Access Compliance Report

Public Rights-of-Way

(Curb Ramps)

Intersection ID: 10020058	Main Street: ASHEFORD_WOODS_LN	Cross Street: N/A	Location: SE
ADA ID: 8AFA9FD73AE1	Ramp Type: Perp	Initial Pass/Fail: Pass	Overall Compliance: No
Codes/Mitigation Info/Possible Solution		Field Measurements/Component Compliance	
Severity Score: 10

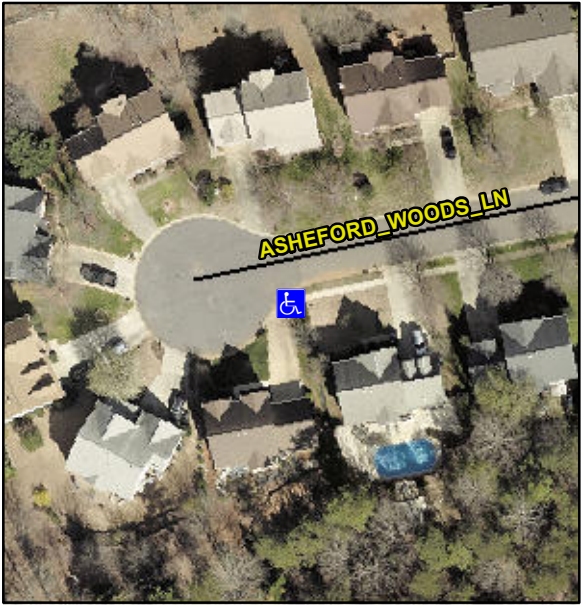
Possible Solutions:	Compliance	Description	Data	Compliance	Description	Data
	Remove & Replace Entire Ramp.	N/A	Ramp Length (in)	60.0	Yes	Ramp Slope (%)	5.4
	Remove & Replace Gutter.	Yes	Ramp Width (in)	48.0	Yes	Ramp XSlope (%)	1.8
		N/A	Flare Type LT	Sloped	N/A	Flare Type RT	N/A
		N/A	Flare Slope LT (%)	6.2	Yes	Flare Slope RT (%)	5.8
		N/A	Flare Traversable LT?	Yes	N/A	Flare Traversable RT?	Yes
		No	Landing Length (in)	34.5	No	DWS Provided?	No
		Yes	Landing Width (in)	48.0	N/A	DWS Contrast?	No
		No	Landing Slope (%)	2.2	N/A	DWS Length (in)	N/A
		Yes	Landing X Slope (%)	0.3	N/A	DWS Full Width?	No
<p>Surveyor Notes:</p> <p>N/A</p> <p>PROW/ADA:</p> <p>R304.2.1, R304.2.2-Perp, R304.3.2-Para, R305, R304.5.3</p>		N/A	Landing Curb? (Y/N)	No	N/A	DWS Offset (in)	N/A
		N/A	Shared Landing?	No			
		Yes	Gutter Ponding?	No	Yes	Gutter Slope (%)	0.7
		Yes	Gutter Lip Ht (in)	0.0	No	Gutter X Slope (%)	2.2
		N/A	Painted X Walk1?	No	N/A	Painted X Walk2?	N/A
